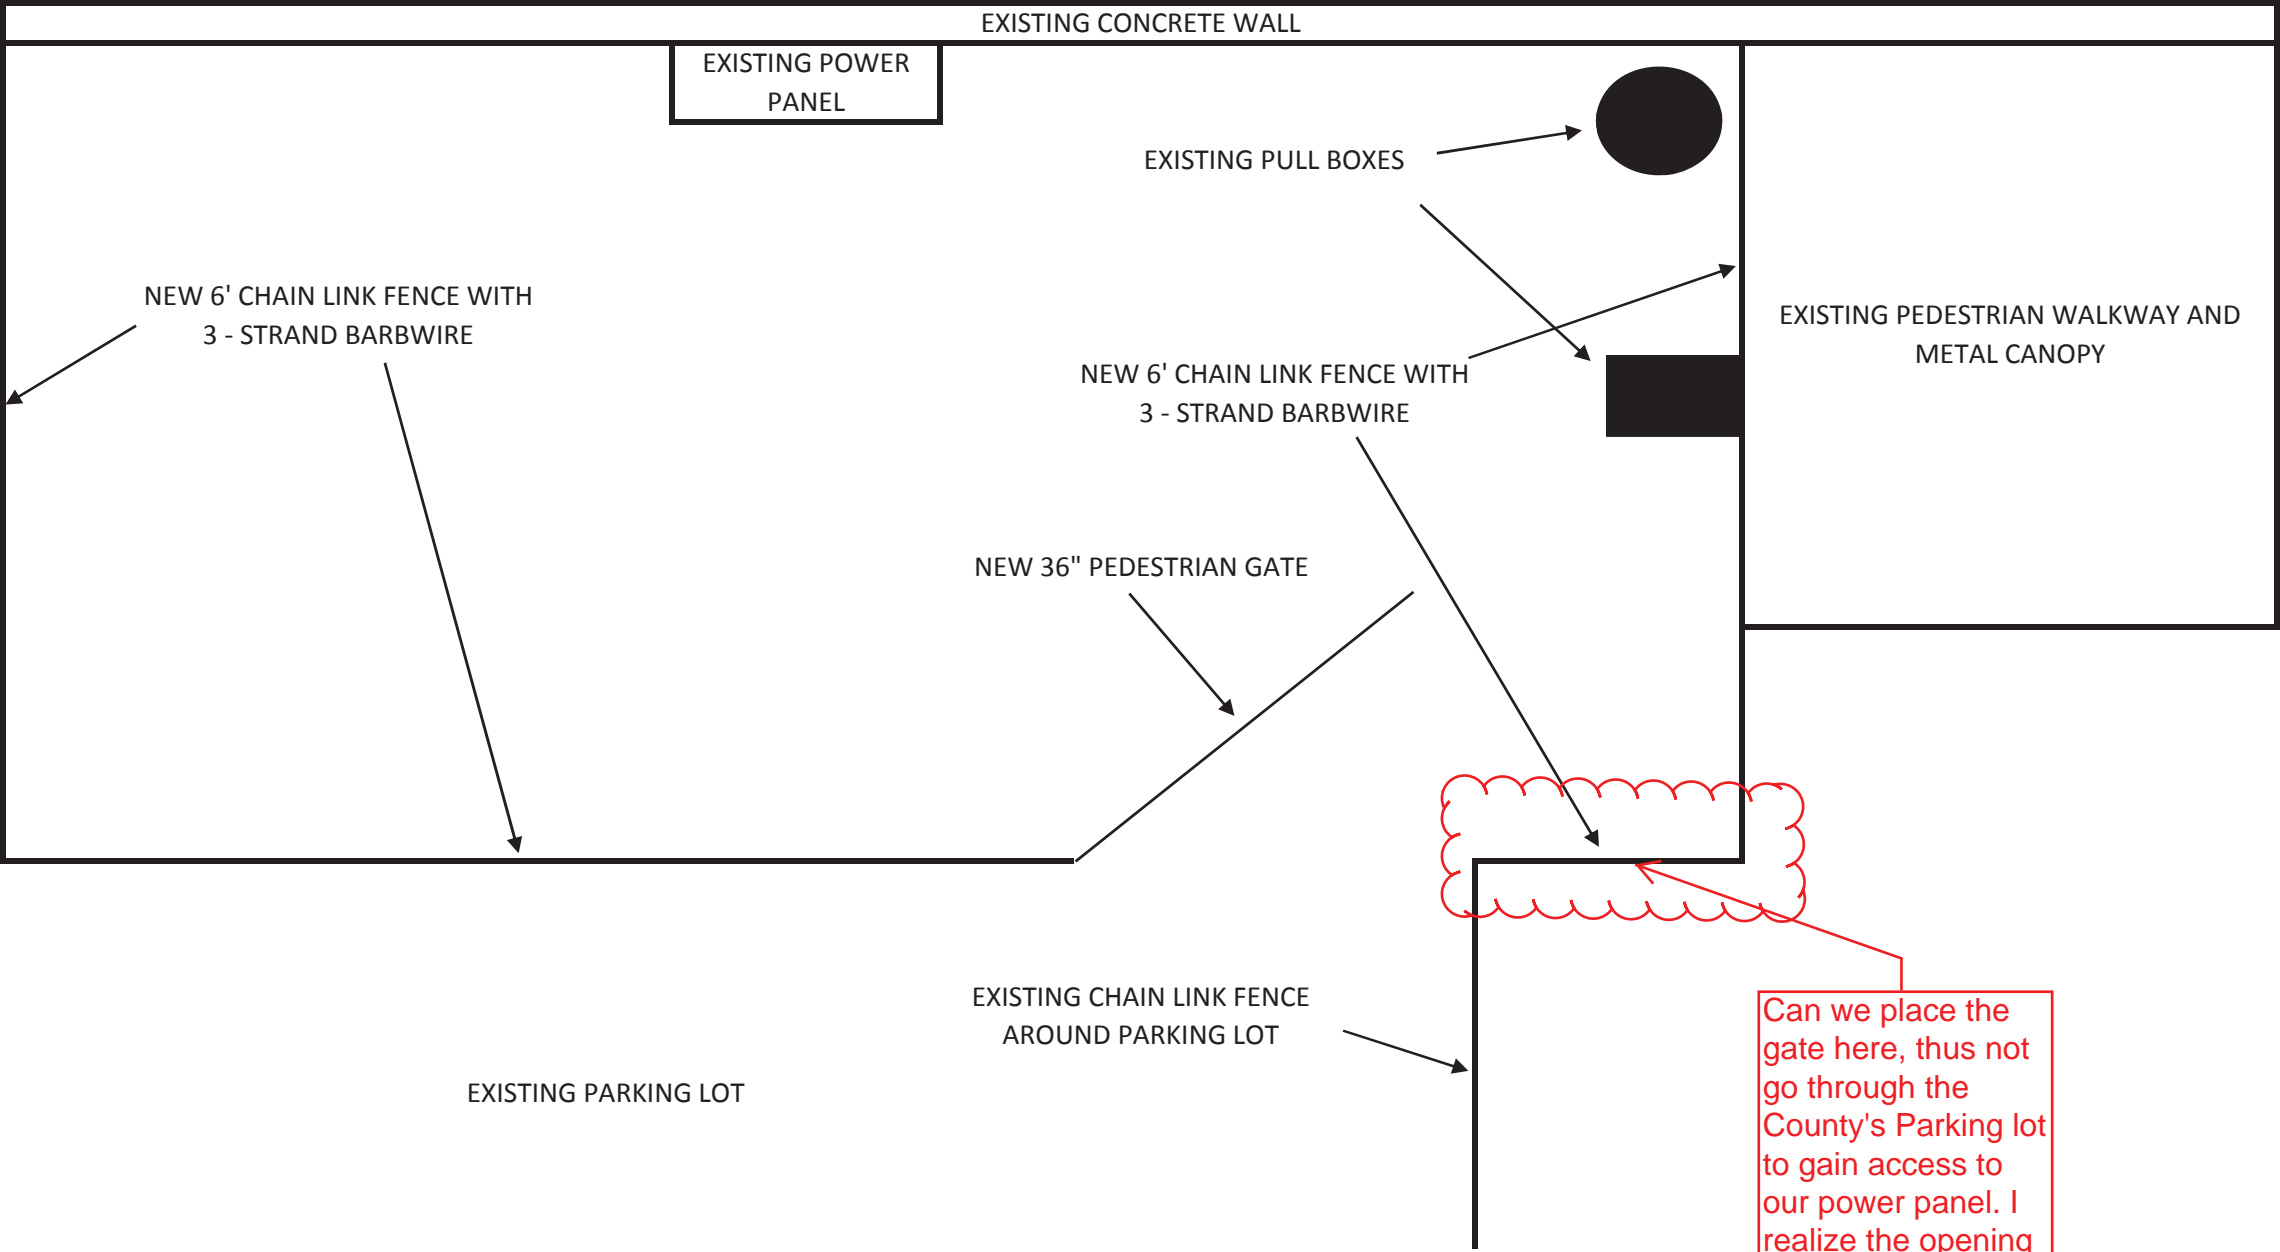
Can we place the gate here, thus not go through the County's Parking lot to gain access to our power panel. I realize the opening may be less than 36-inches. Possibly a minimum of 24-inches.
